# Groundwater Application Review Summary Form

Application # G- 19385

GW Reviewer Grayson Fish Date Review Completed: 12/11/2023

# PUBLIC INTEREST REVIEW FOR GROUNDWATER APPLICATIONS

**Theis (1935) Distance Drawdown Modeling Parameters and Results**

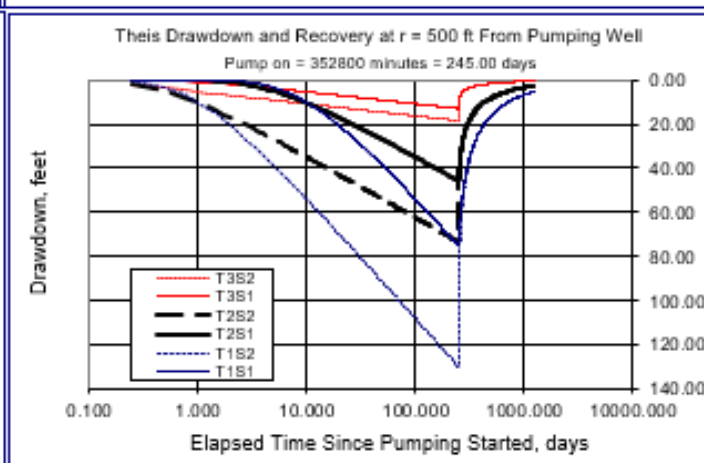
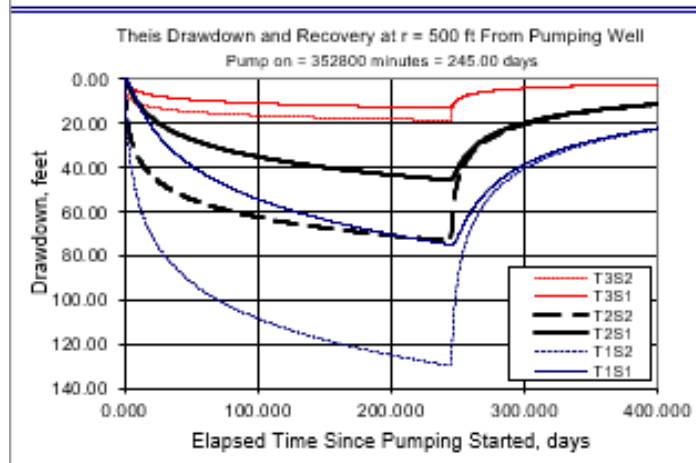
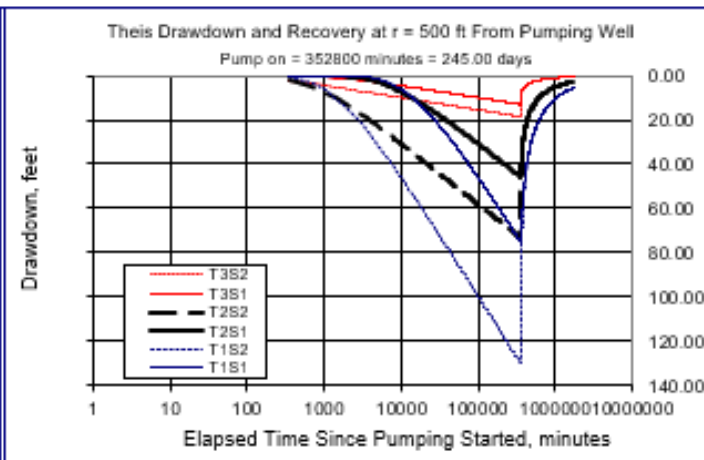
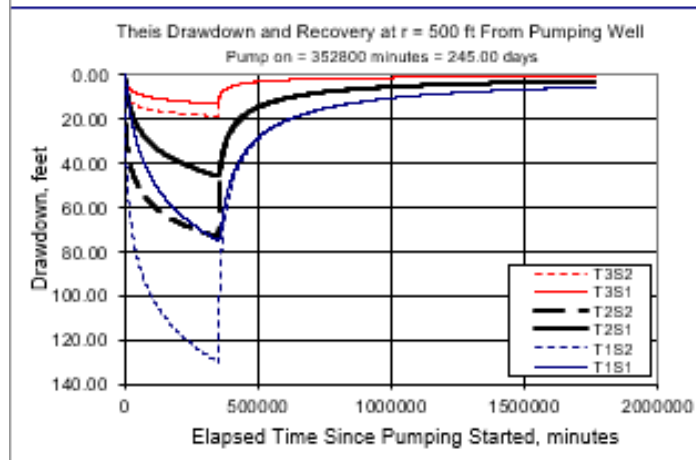
1200 feet from the proposed **POA 1**. The Theis equation (1935) is used to estimate maximum well-to-well interference from the proposed POA (78 gpm for 245 days) to a potential well 500 feet away. The resulting drawdown was calculated to be approximately 40 feet or greater indicating interference is likely. However, given the uncertainties introduced when applying the Theis equation to fractured rock aquifers and the variability in degree of interconnectivity of subsurface fractures, a preponderance of evidence does not exist to determine that injury is likely to occur. Permit conditions should be applied as referenced in B1(d)(i) of this review form.
